Subject: Response to Request for Additional Information Regarding Licensing Amendment Request to Revise Technical Specifications (TS) Surveillance Requirements and TS Table for Mathematical Symbols and Use of Allowable Values in the Place of Analytical Limits
Cooper Nuclear Station, Docket 50-298, DPR-46

**Response to Request for Additional Information Regarding Licensing Amendment Request
to Revise Technical Specifications (TS) Surveillance Requirements and TS Table for
Mathematical Symbols and Use of Allowable Values in the Place of Analytical Limits**

**Cooper Nuclear Station
Docket 50-298, DPR-46**

Figure 1, Rod Block Monitor operating regions showing associated setpoint values.

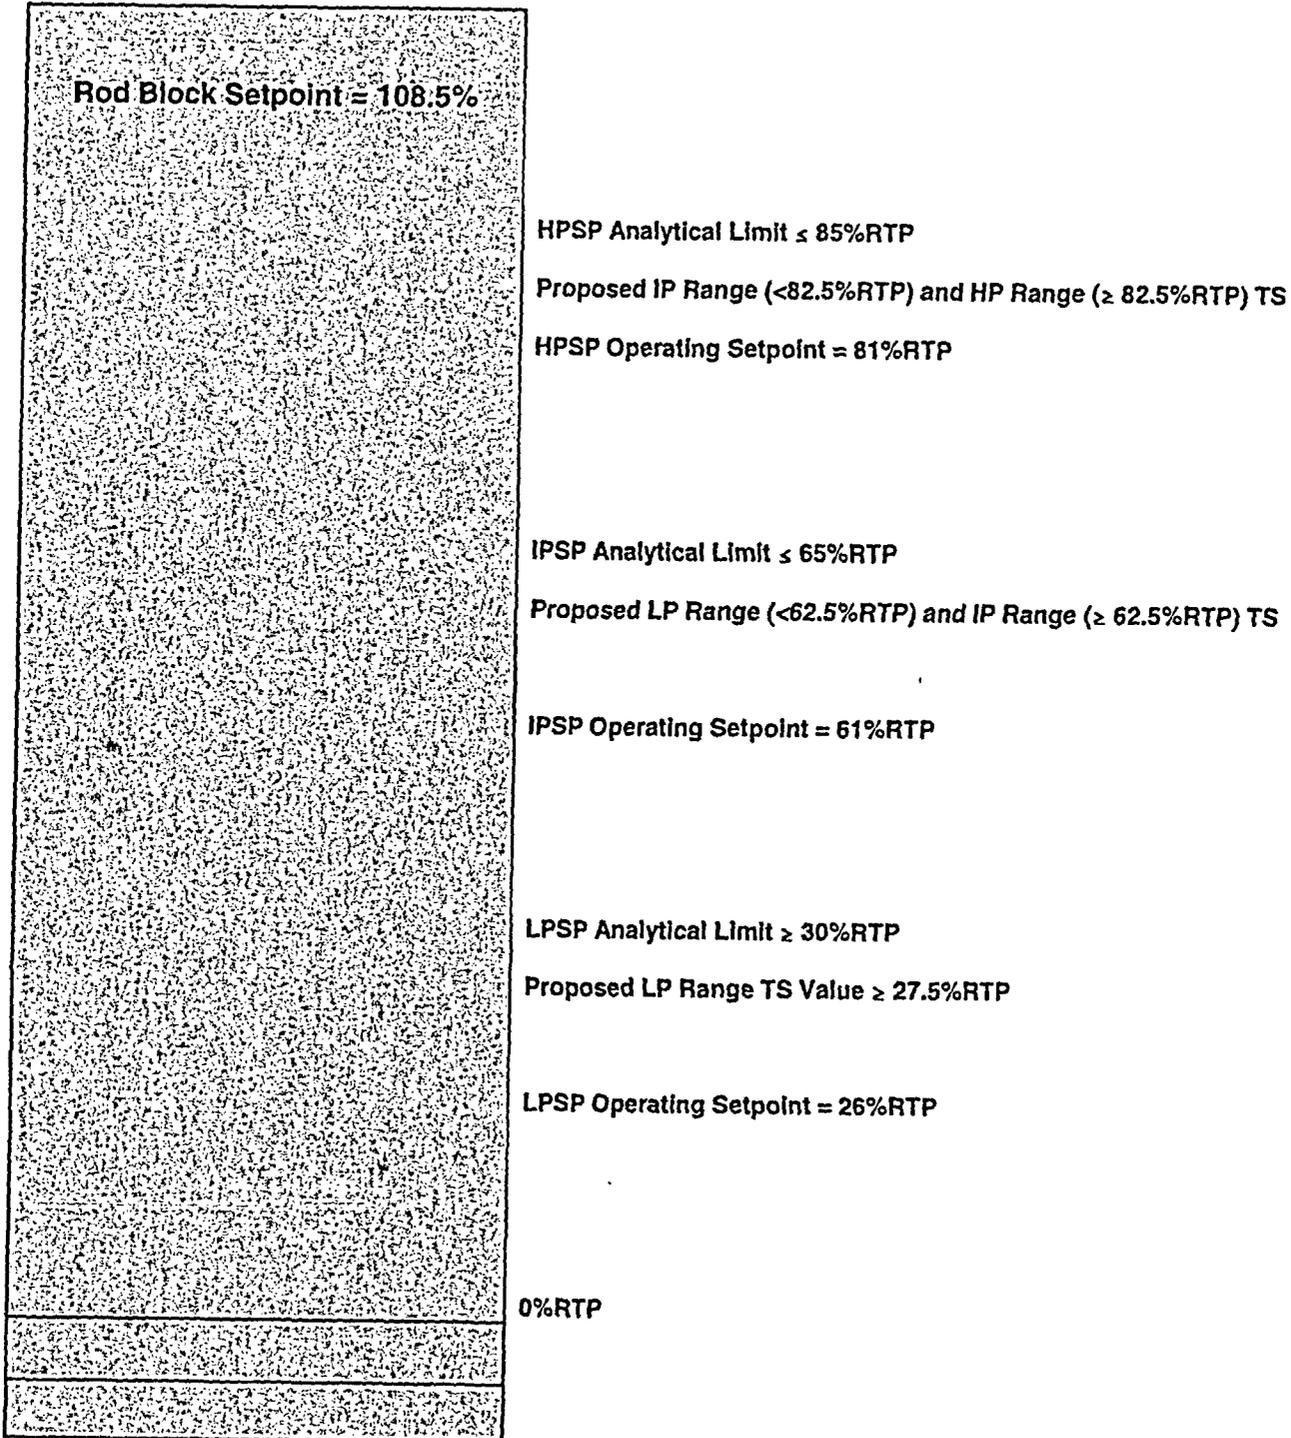
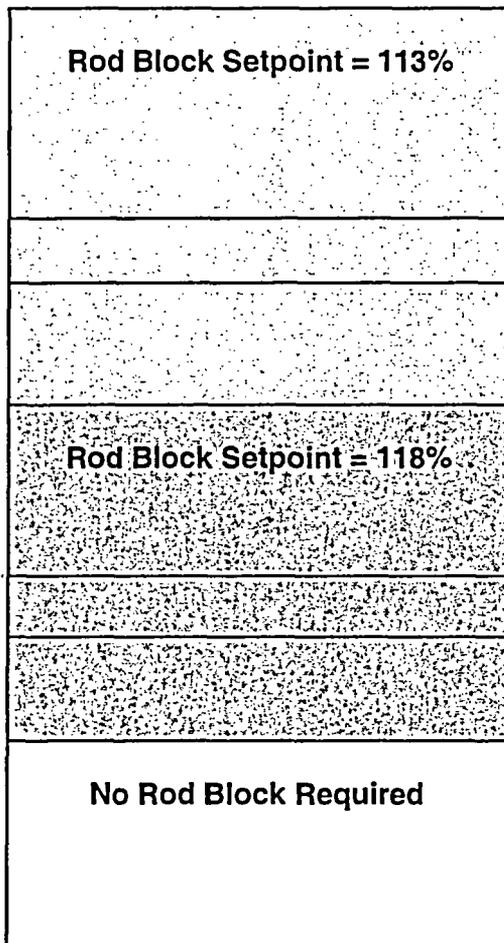
For all RBM Functions in TS Table 3.3.2.1-1 and for the "no-trip" zones in the TS Bases for the RBM (B3.3.2.1, page B3.3-45), please indicate whether overestimation or underestimation of thermal power is more conservative and provide the reasoning behind each determination. Show that the proposed margins are on the correct side (i.e., where the margins produce, rather than detract from, conservatism) of each zone boundary. Explain why no margin is needed at the 90 percent power level.

Please refer to the graph on the following page along with the following explanation. The way that the setpoints for the various regions were determined has not changed from when Cooper converted from flow-biased RBM setpoints to the current three zone method. Instrument uncertainties are deducted from the Analytical Limit (AL) to determine the Allowable Value (AV) and Nominal Trip Setpoint (NTSP), per GE Setpoint Methodology. Additional tests are then applied to the NTSP (i.e. LER Avoidance, Required Limits Evaluation) and a final operating setpoint determined. In the case for the transition from the 'No Rod Block Required' region less than 30% RTP to the low power (LP) region, the conservative situation is to have the rod block in effect prior to reaching 30%, so the calculated AV is 27.5% and the setpoint is 26%. As mentioned, clearly this is conservative. For the transition from the low power setpoint (LPSP) to the intermediate power setpoint (IPSP) and the IPSP to high power setpoint (HPSP), the same calculational methodology was used, i.e. deducted instrument uncertainties from the AL to determine the AV and NTSP. In those two cases, it is conservative to have the transition region below the AL (and also below the AV) and use the rod block setpoint of the "higher region." Specifically, when moving from the LP region to the IP region, the rod block setpoint will shift from 118% down to 113% at 61% RTP, even though the rod block setpoint could be 118% up to the AV of 62.5% RTP. The same discussion holds for the transition from the IP region to the HP region. Additionally, an underestimation of thermal power when operating just above the AL will still result in a shift to the next higher region's rod block setpoint before reaching the AL, while an overestimation of thermal power will cause a shift to the next higher region at some point below the AL, both of which are more limiting.

The proposed change to the "algebraic signs" in SR 3.3.2.1.4 and Table 3.3.2.1-1 (Notes) is based on our determination that it is conservative to ensure that the rod block setpoint for the next higher region is in effect prior to the AL because that rod block setpoint is a lower value, and thus more limiting.
